STARBUCKS COFFEE COMPANY
PORTION OF PARCEL 1-A, TRACT BB
MONARCH VILLAGE CONT 0.5785 ACRES
CITY OF ALBUQUERQUE, COUNTY OF BERNALILLO, STATE OF NEW MEXICO
SITE CONSTRUCTION PLAN

63433-001
STARBUCKS DRIVE-THRU
700 JUAN TABO NE
ALBUQUERQUE, NM 87123

SHEET TITLE:
GRADING & DRAINAGE PLAN
AS-BUILT
SHEET NUMBER:
C301

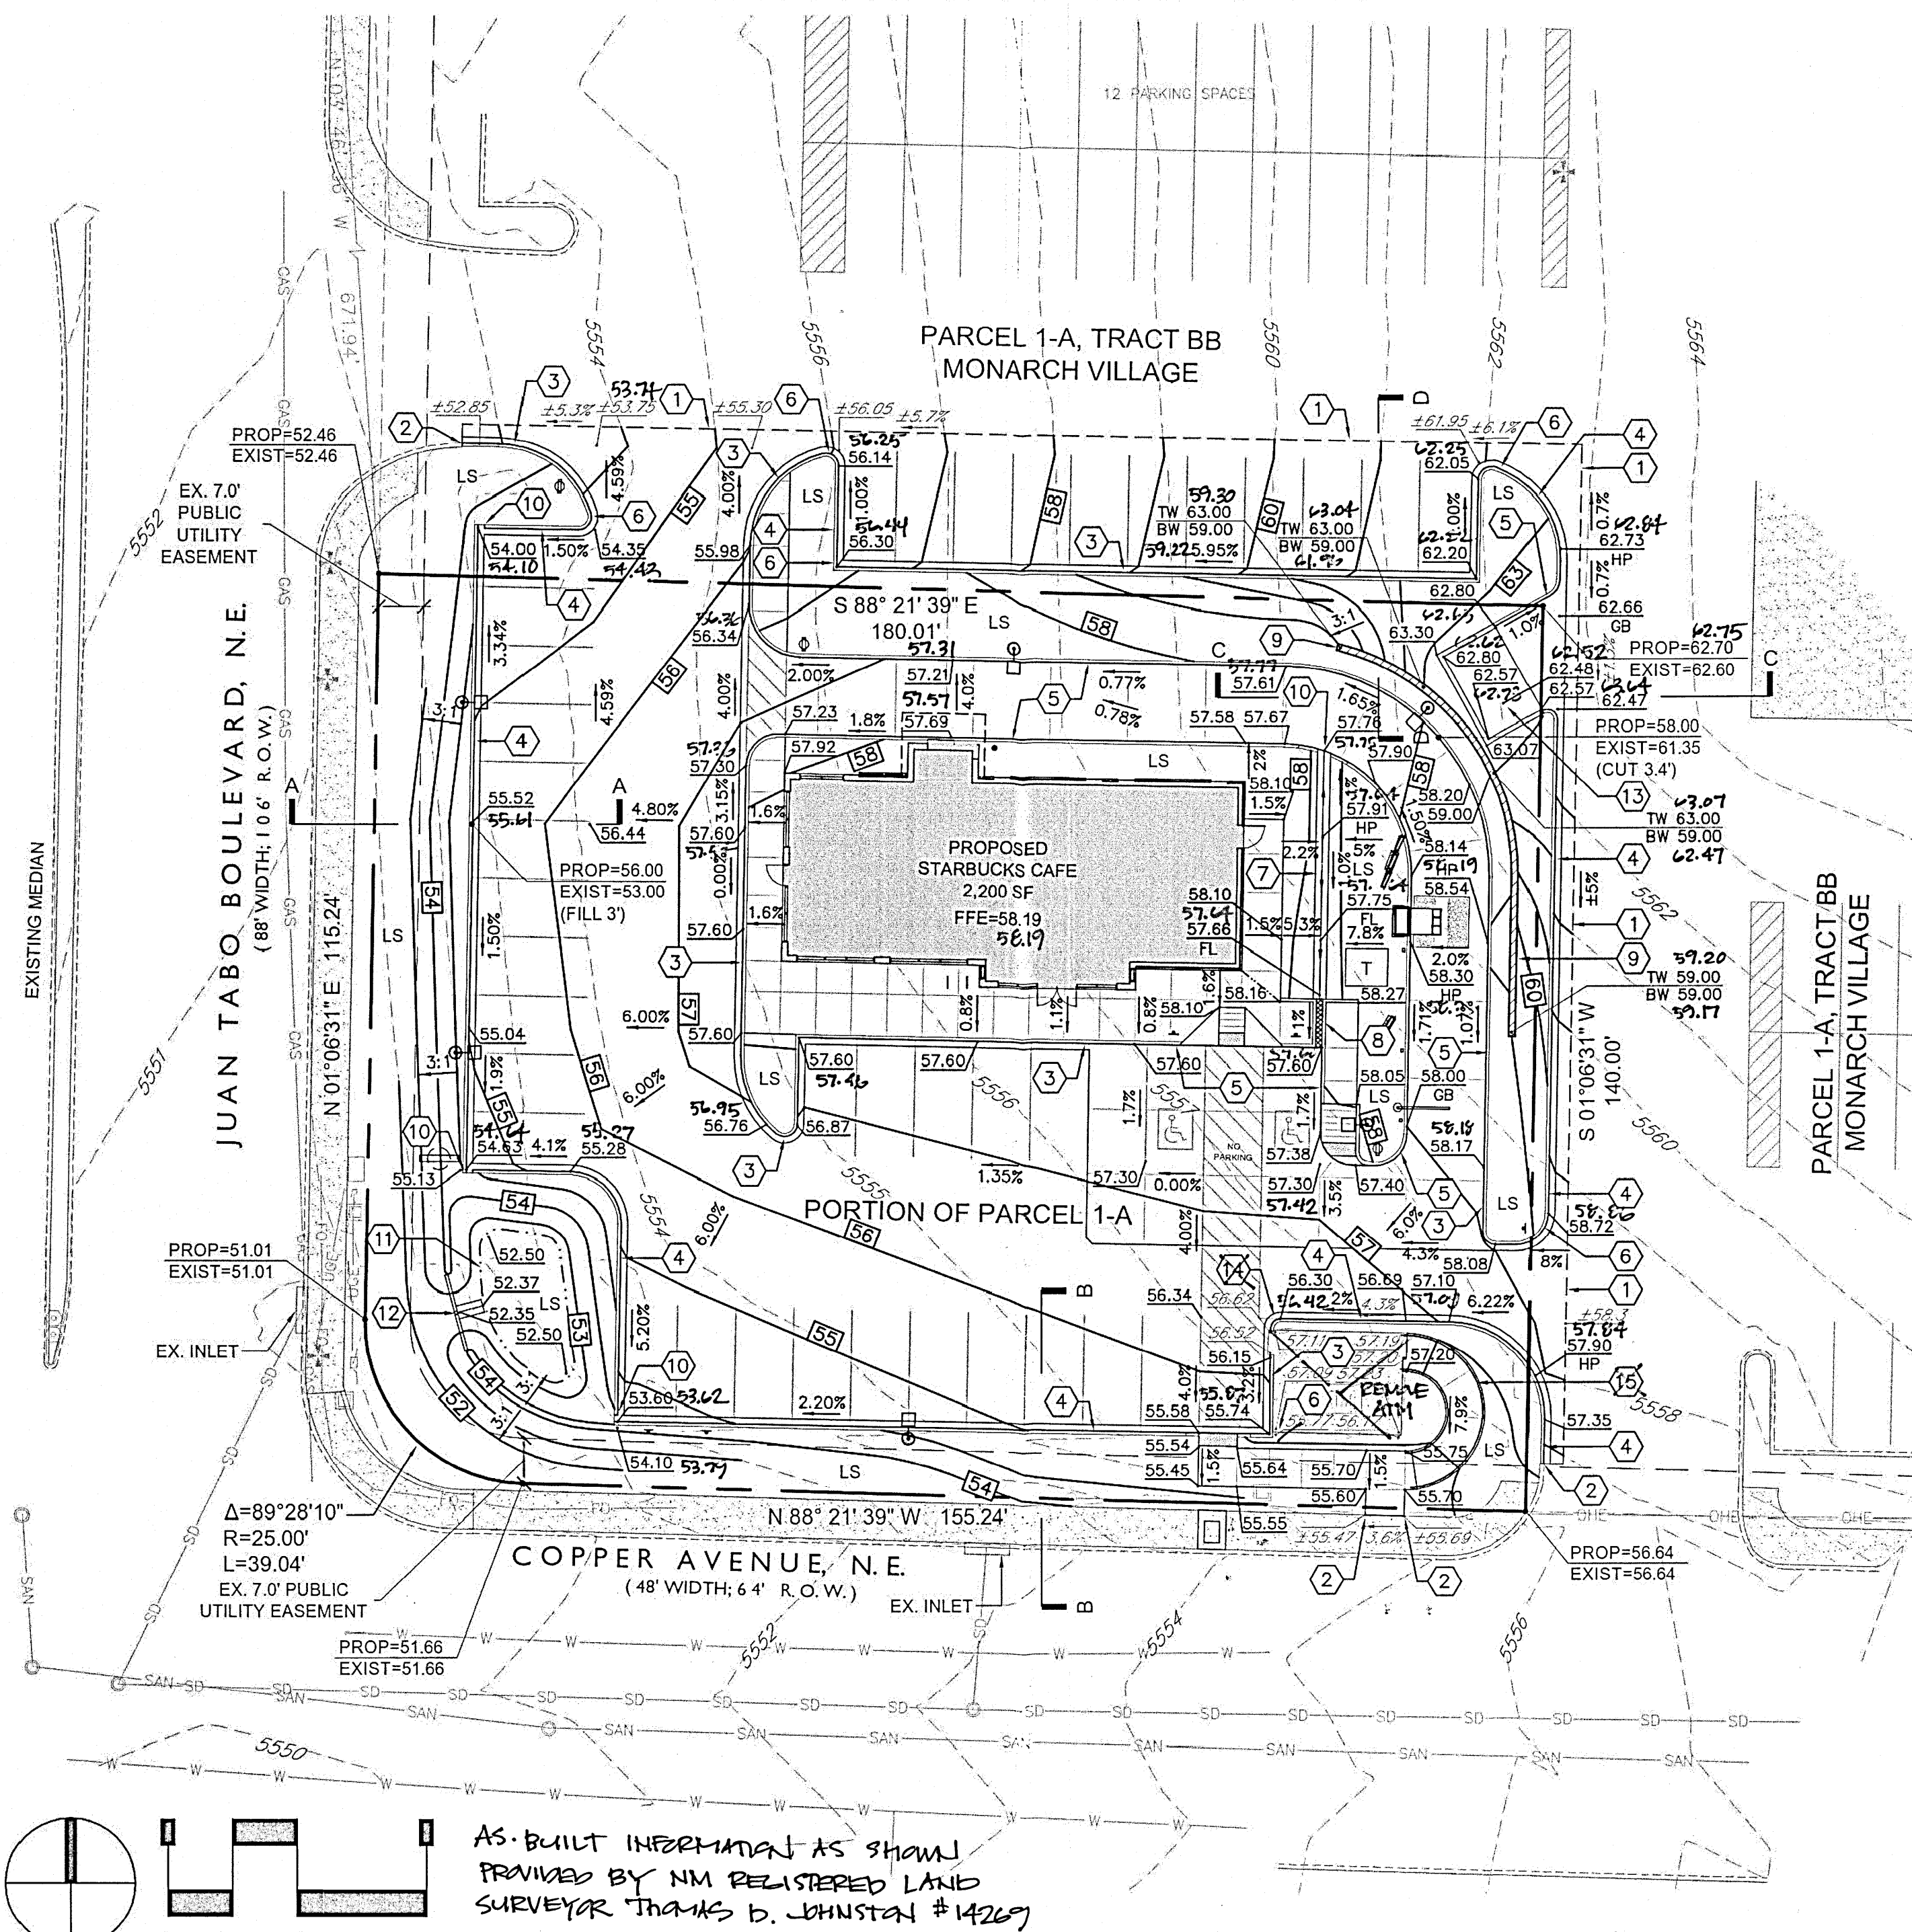
Upon review it has been found that the 2-foot wide concrete pan on the east side of the building conveys runoff entirely to the south rather than portions to the south and portions to the north. Portions of the pan are also constructed with a flat slope. The finished grade elevations of and near the trash enclosure suggest portions of the adjacent drive aisle may contribute minor runoff to the enclosure. The pond elevations indicate a lower pond bottom and a lower pond weir than described on the approved plans; however, calculations indicate provision of the design volume. In addition and as approved by the city, the ATM that previously existed at the southeast corner of the site has been removed. These and other deviations from the grading and drainage design described on the approved plan(s) represent discrepancies which are minor in nature and/or should impact maintenance of the property rather than the overall drainage design intent.

Based on the review described herein, of the information listed herein, and of this information only, it appears the improvements associated with the grading and drainage aspects of the project have been graded and will drain in substantial compliance with the overall design intent of the approved plan(s).

SHEET NUMBER:
C301

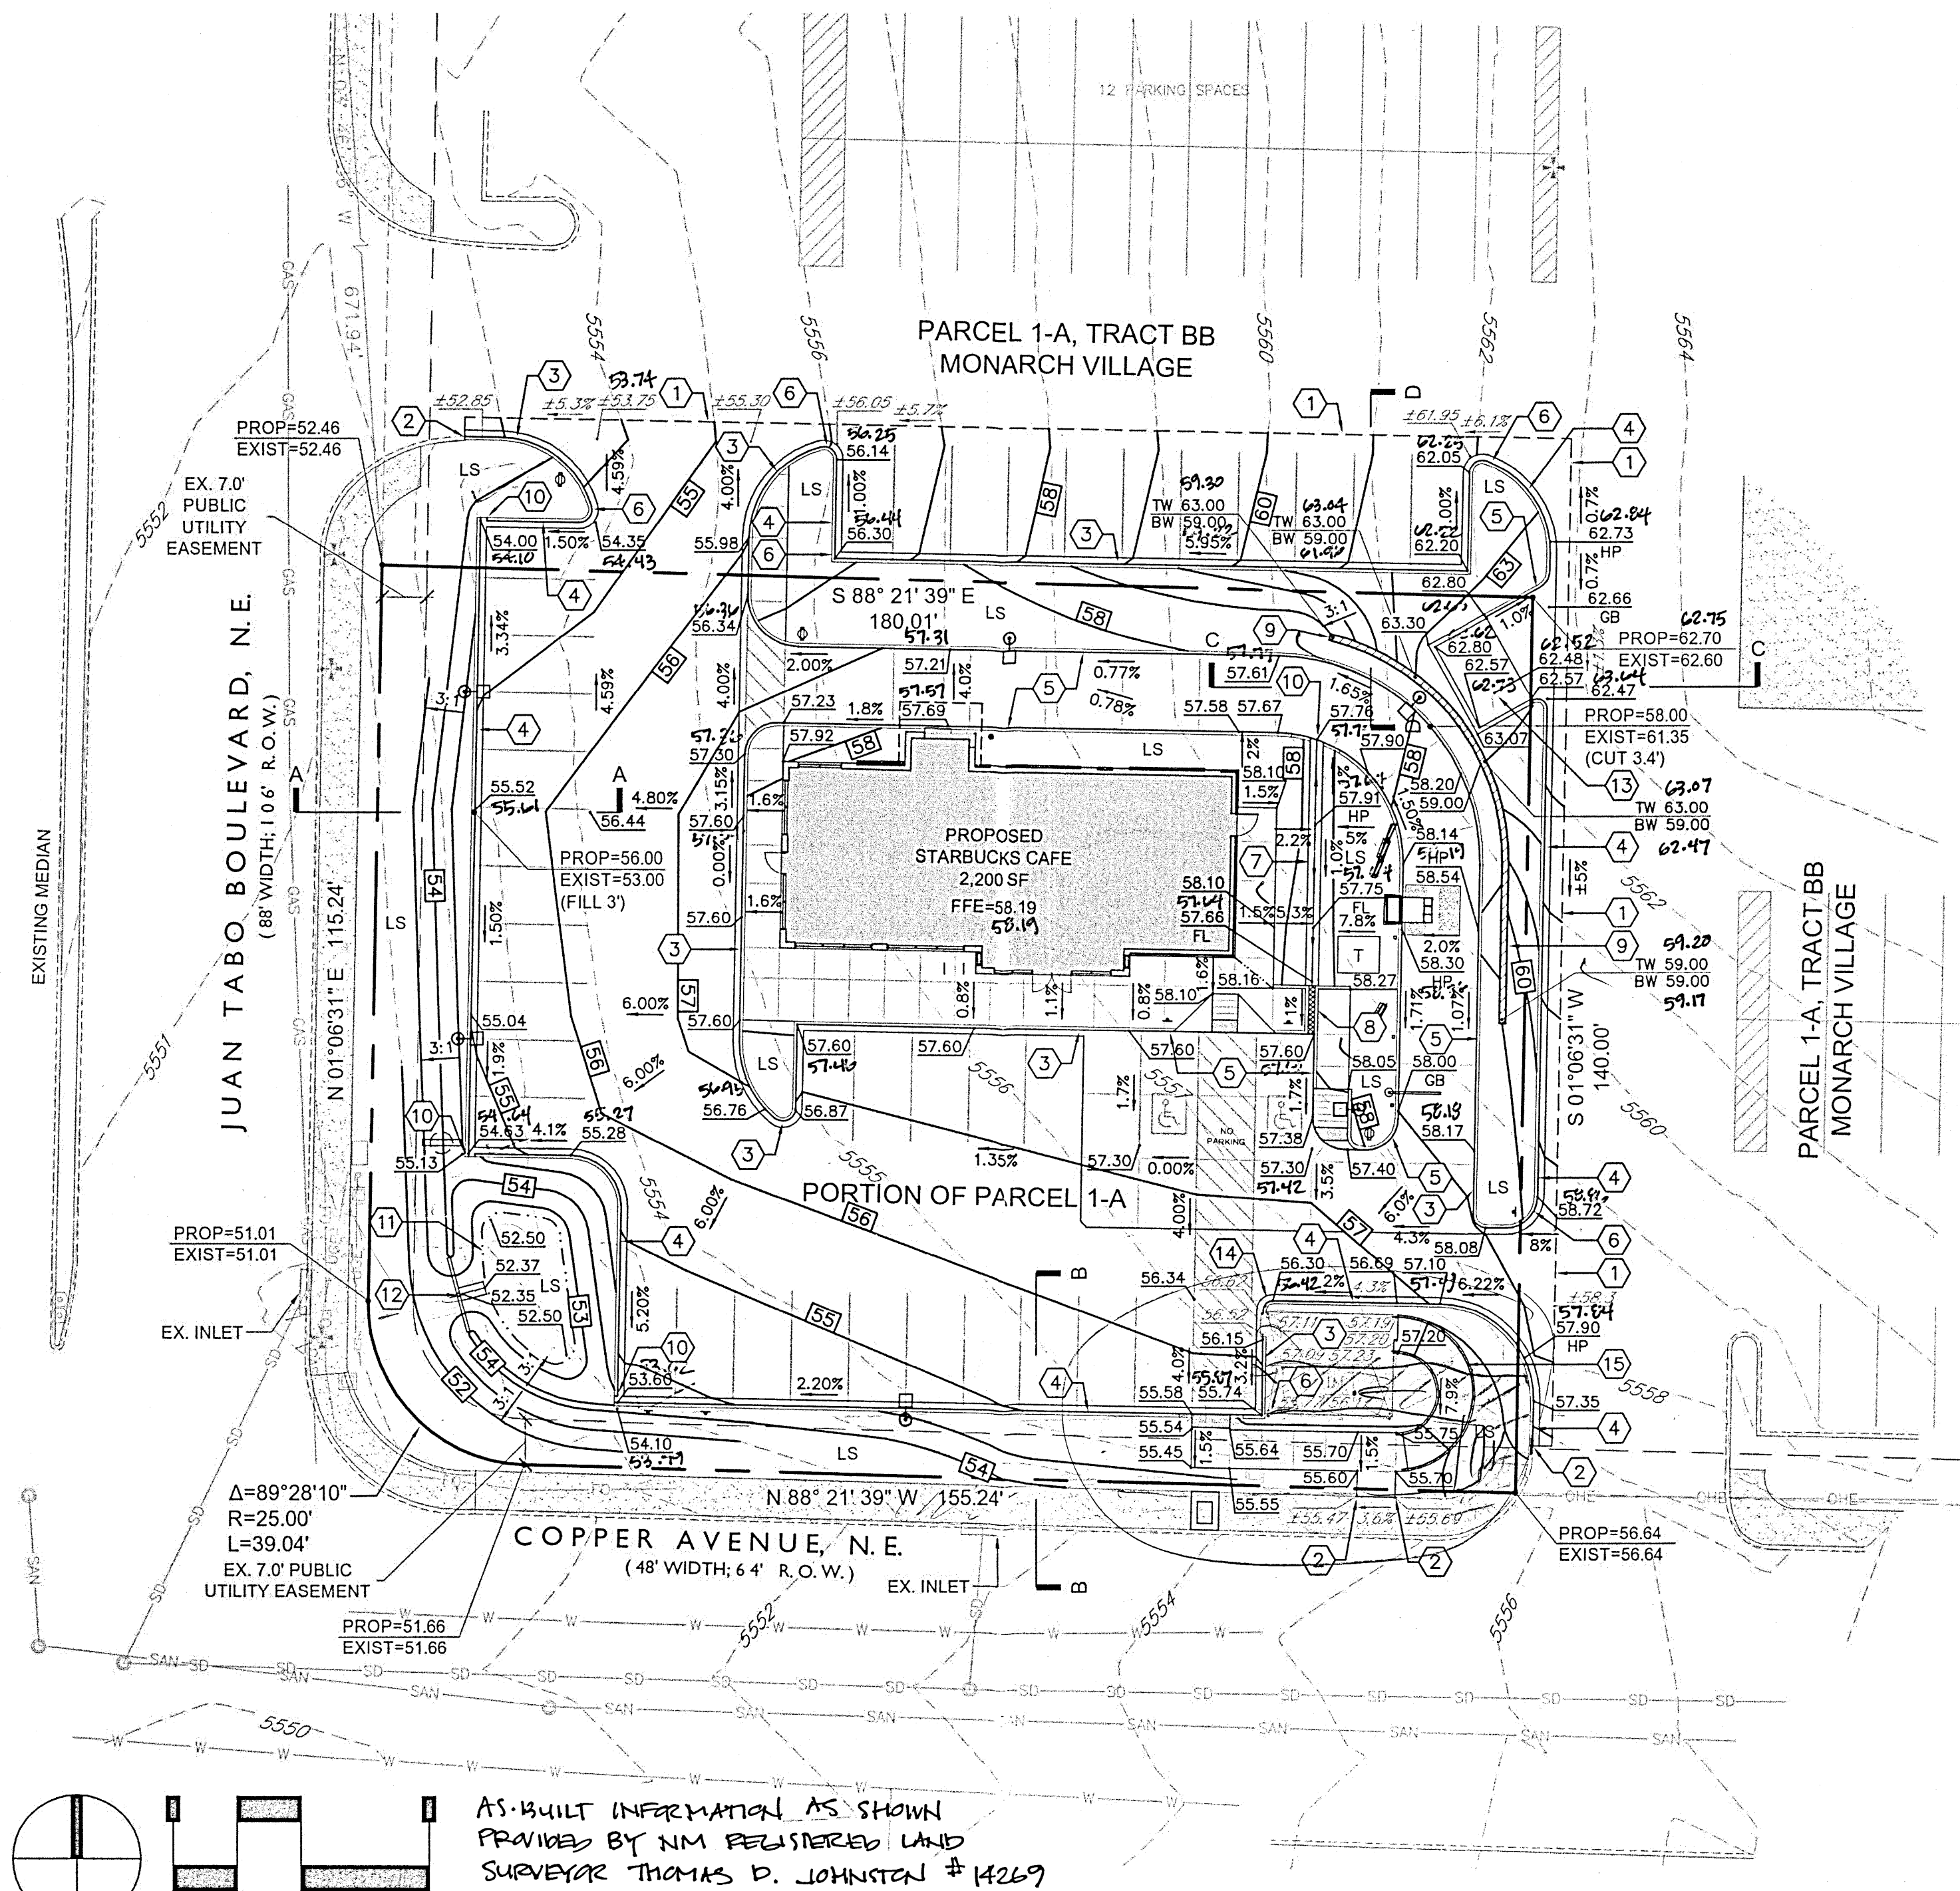
Upon review it has been found that the 2-foot wide concrete pan on the east side of the building conveys runoff entirely to the south rather than portions to the south and portions to the north. Portions of the pan are also constructed with a flat slope. The finished grade elevations of and near the trash enclosure suggest portions of the adjacent drive aisle may contribute minor runoff to the enclosure. The pond elevations indicate a lower pond bottom and a lower pond weir than described on the approved plans; however, calculations indicate provision of the design volume. These and other deviations from the grading and drainage design described on the approved plan(s) represent discrepancies which are minor in nature and/or should impact maintenance of the property rather than the overall drainage design intent.

Based on the review described herein, of the information listed herein, and of this information only it appears the improvements associated with the grading and drainage aspects of the project have been graded and will drain in substantial compliance with the overall design intent of the approved plan(s).
